DETAILED ACTION

In view of the appeal brief filed on October 7, 2010, PROSECUTION IS HEREBY REOPENED. Rejections are set forth below. To avoid abandonment of the application, appellant must exercise one of the following two options:

Art Unit 1776

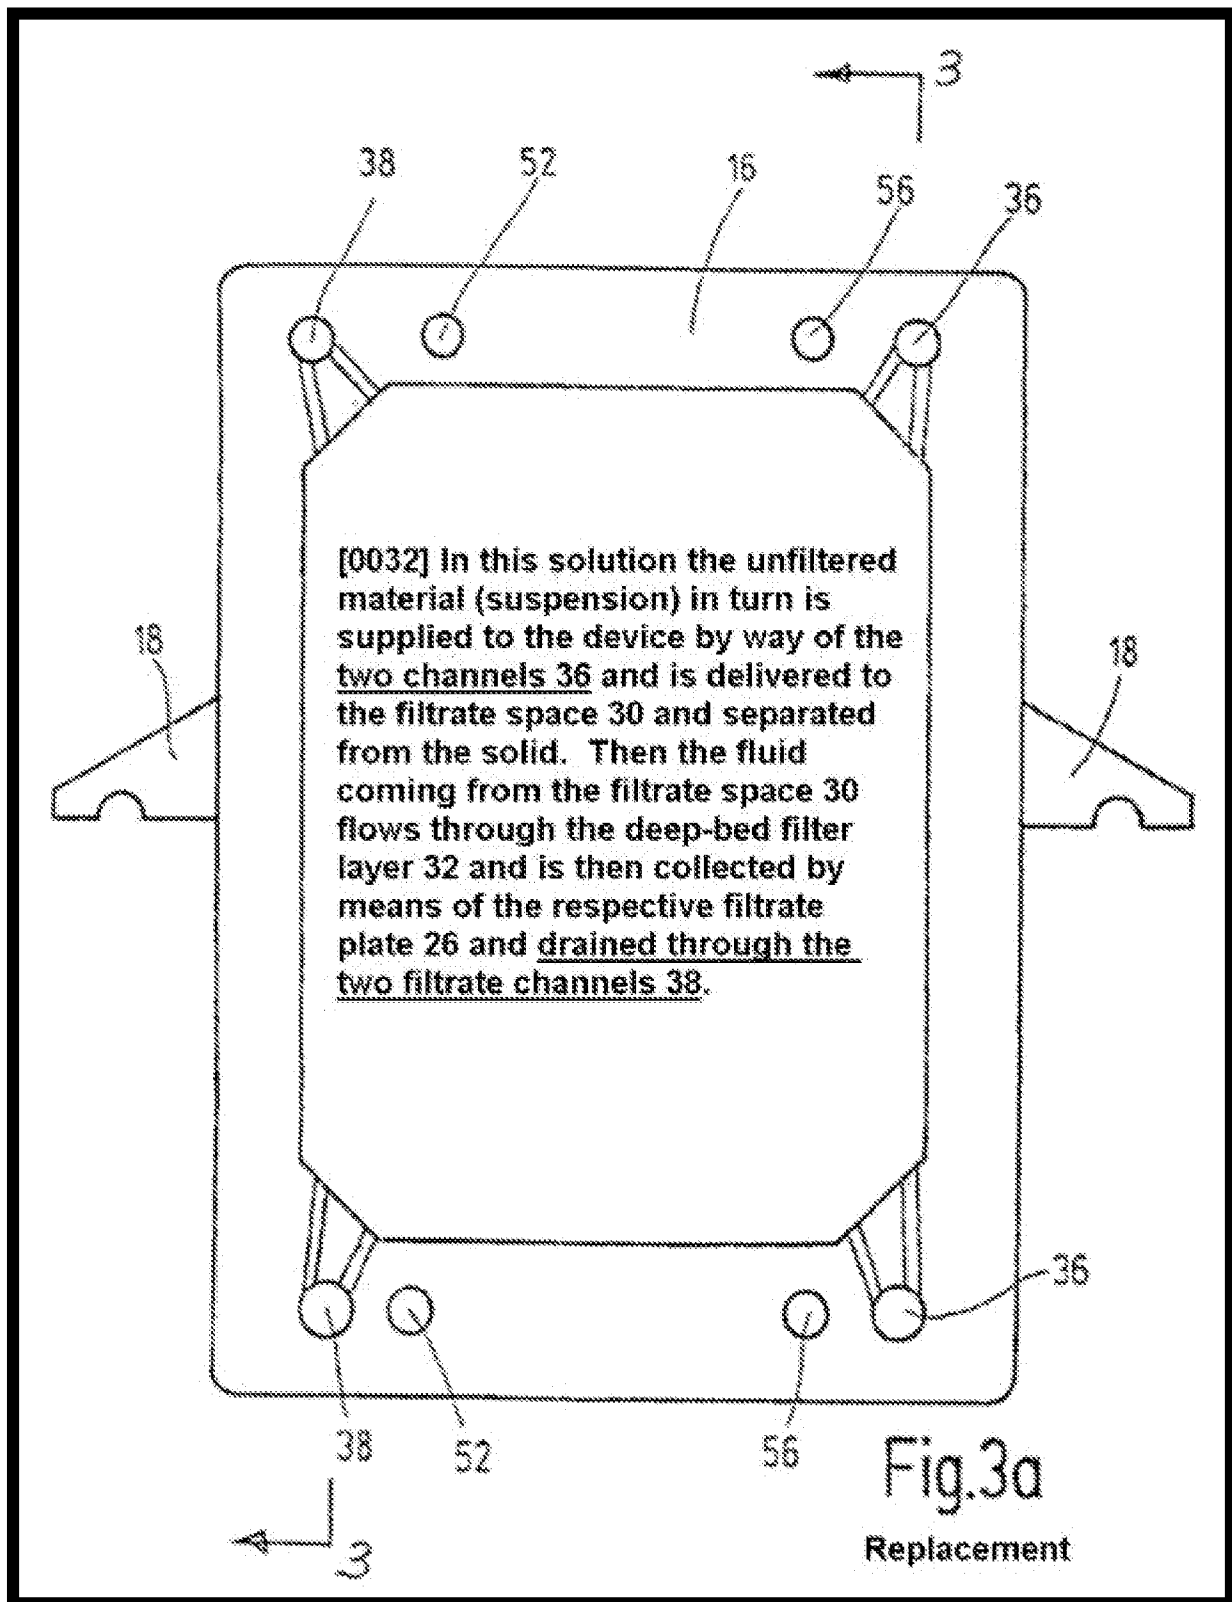
Independent claims **8** and **14**, the only two presently pending independent claims, specify **“discharging filtrate through an output,”** and **“an output for discharging filtrate,”** respectively. It is unclear how filtrate arrives at the **“output.”** Referencing the replacement drawings submitted on **January 21, 2010**, where labels **“f”** have been added to aid in the understanding of the invention by depicting the **“filtering flow”** (Remarks of January 21, 2010; page 8; lines 8-10), it remains unclear how filtrate arrives at the claimed **“output.”** Replacement Fig. 3 depicts nonsequential flow across both filter cloth 46 and laminar filter 32. It is unclear how **“filtering flow”** which passes across filter medium 46 which is adjacent membrane (the third encircled portion from the top of the annotated Fig 3 immediately above) exits pressure chamber 54.

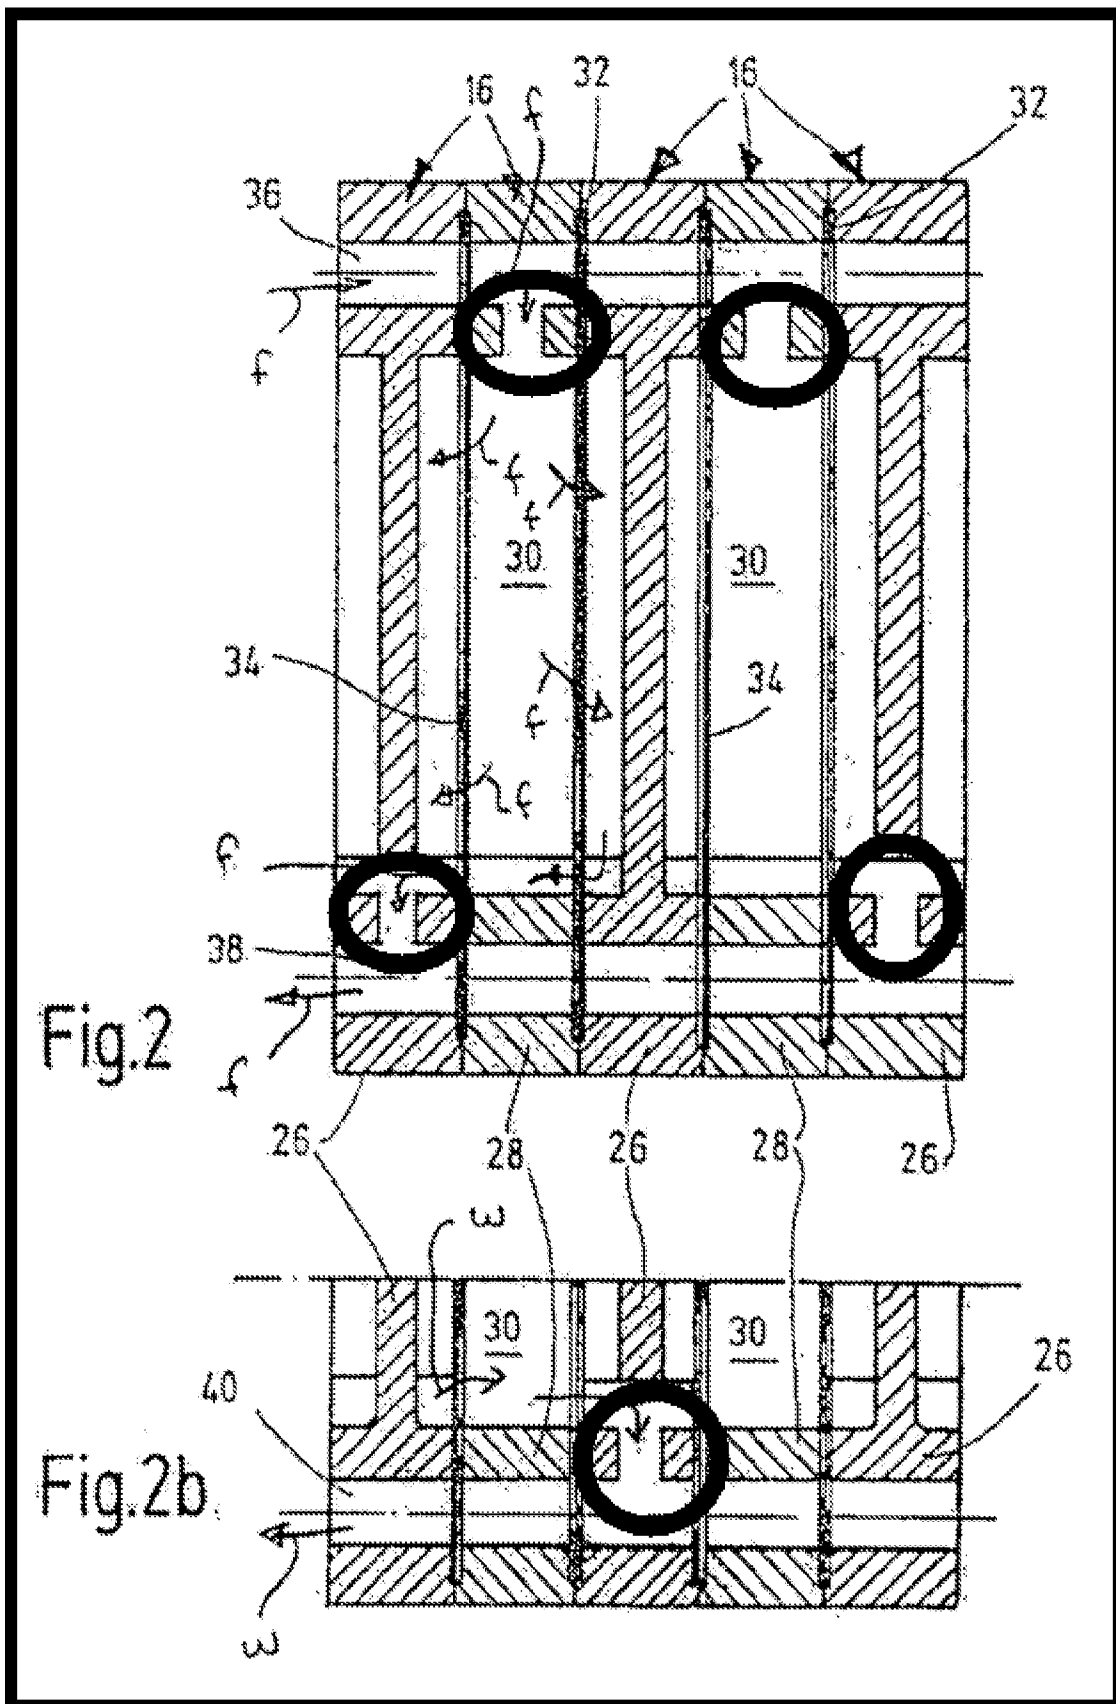
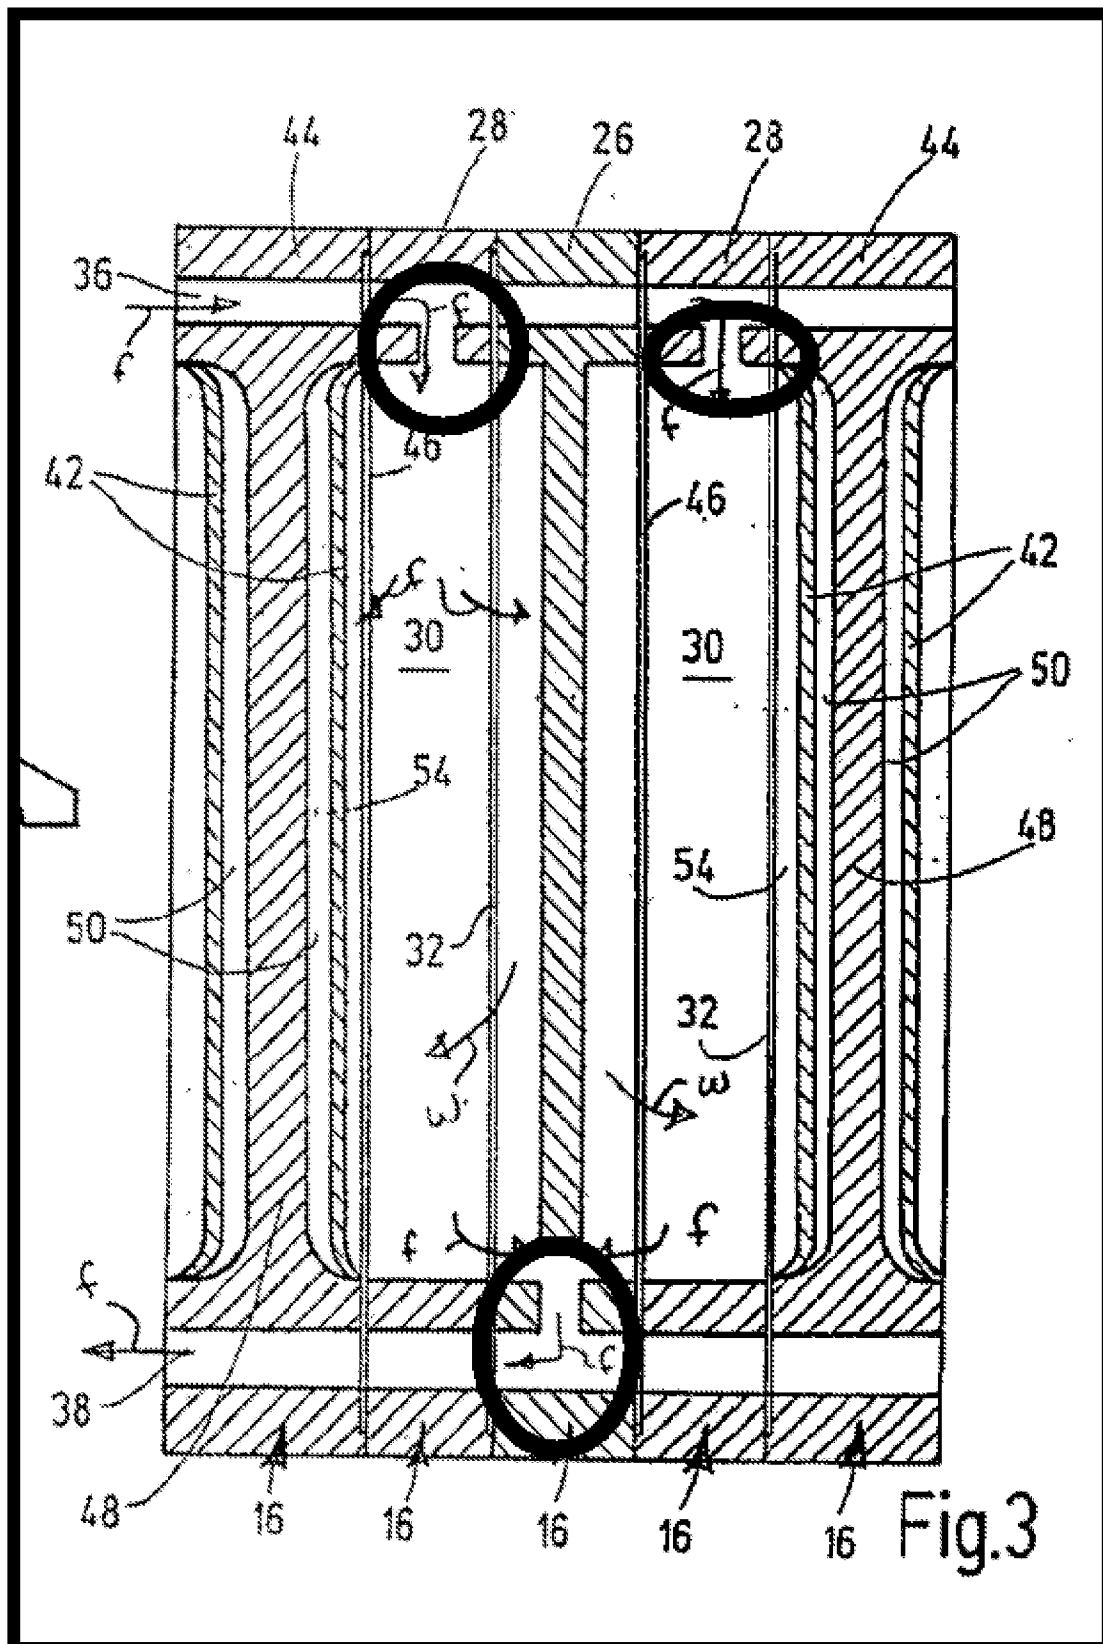
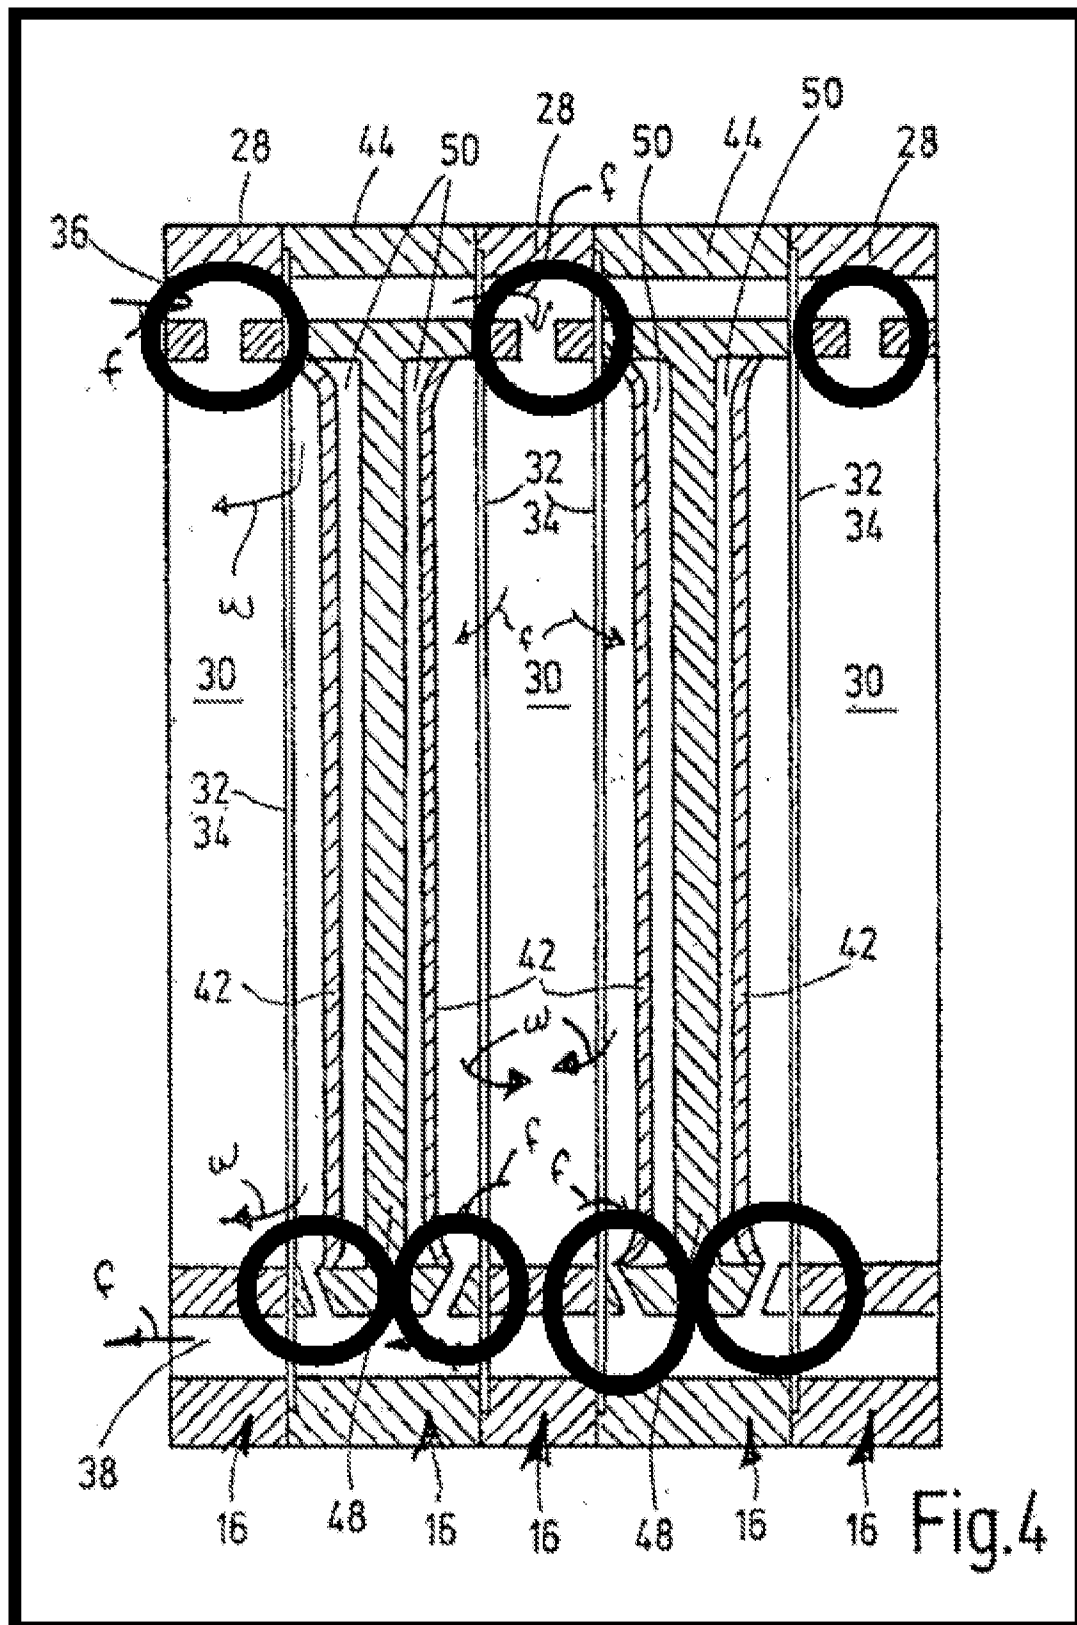
The drawings are objected to because it is **unclear what the unlabeled structure in Fig 3a (elected) et al is, or where it is described in the originally filed specification.** Reference is made to the annotated version of Replacement Fig. 3a below:

The same questions arise with respect to similar structure in **Fig. 2a** and **Fig. 4a**.

Additionally, it is unclear what specific frame parts "**16**" are identified in each of Figures **2a**, **3a** and **4a**. It is unclear why each of Figures **2a**, **3a** and **4a** contains reference numeral "**16**" without an "**arrowhead**" (see Remarks of 1/21/10 page 8; lines 13-16), especially, since no "**sets**" are depicted in these figures.

It is unclear what passages are depicted in the following annotated drawings, where they are described in the specification, or why they are unlabeled. They have been encircled to facilitate analysis:

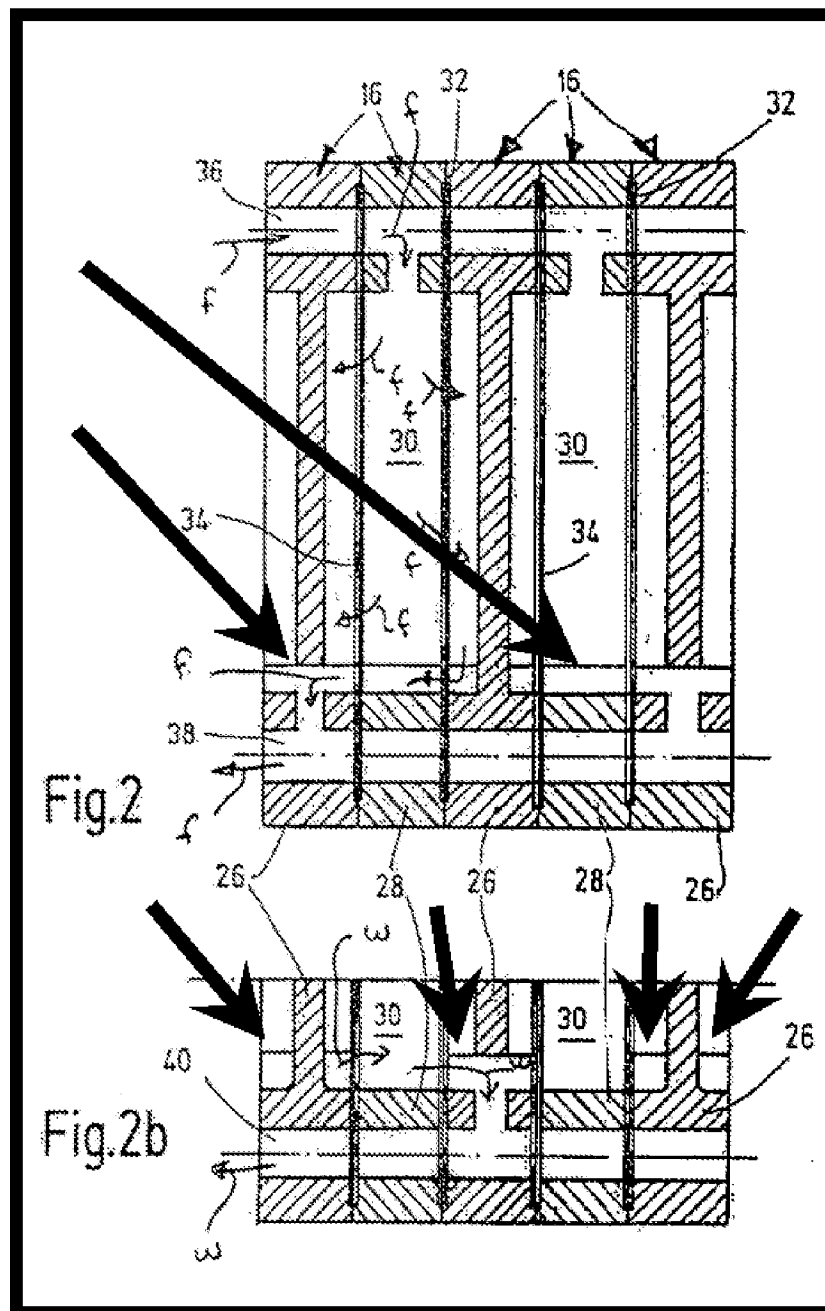
It is unclear what the lines (see annotating arrows) in Replacement Figures 2 and 2b indicate or mean, and, where they are described in the specification. It is unclear why similar lines do not appear in Figures 3 and 4.

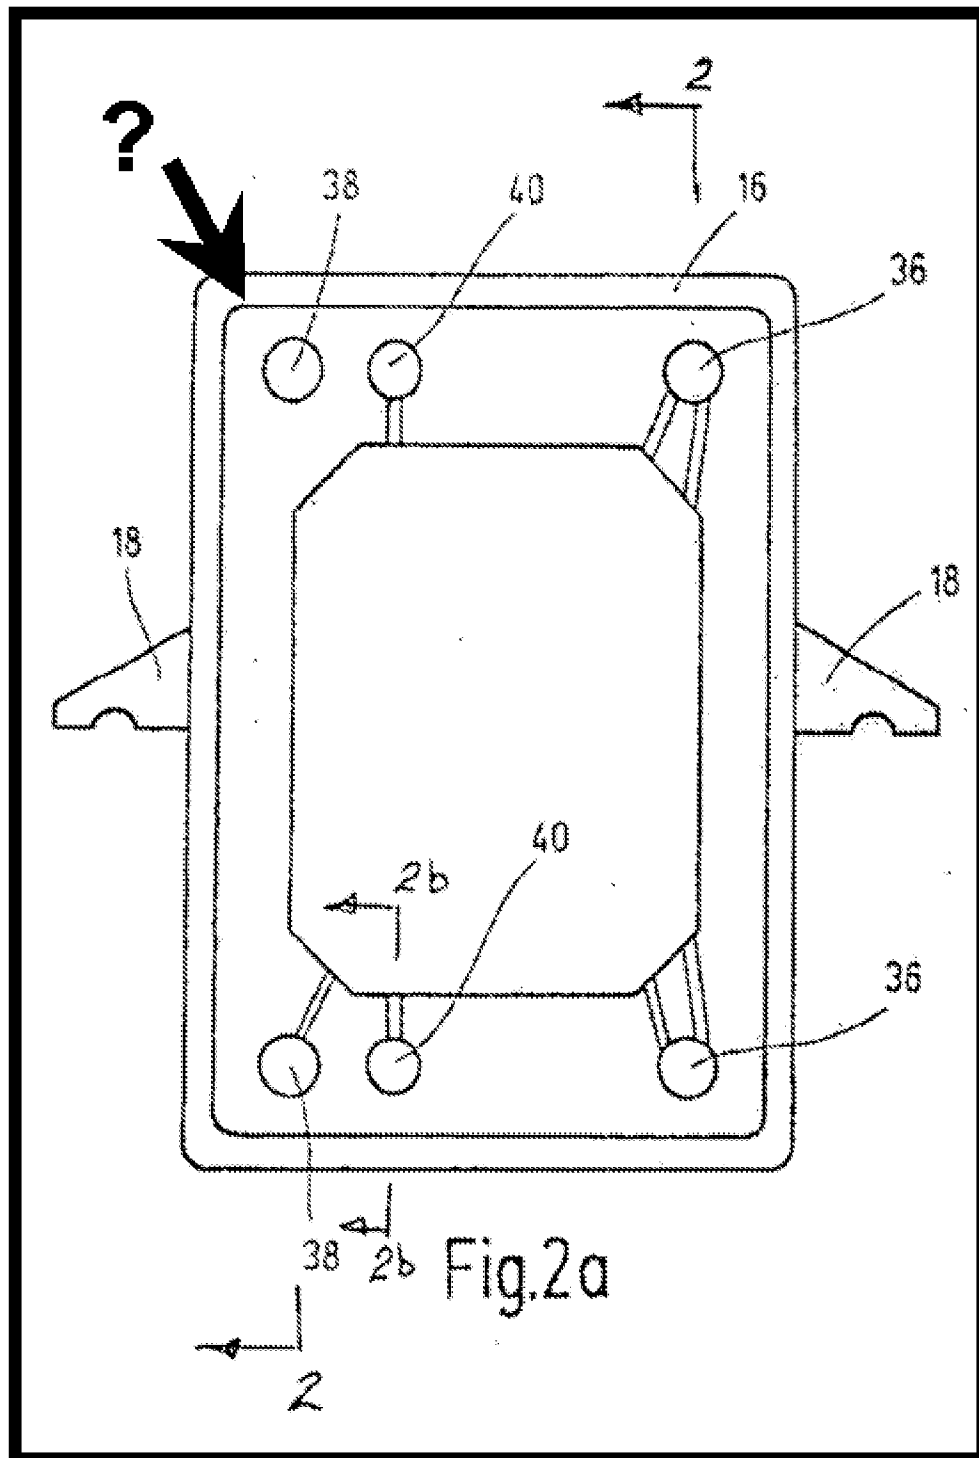
It is unclear what the **perimeter line** (see annotated drawing below) in Figure 2a denotes, or why such a line is not present in Figs 3a or 4a?
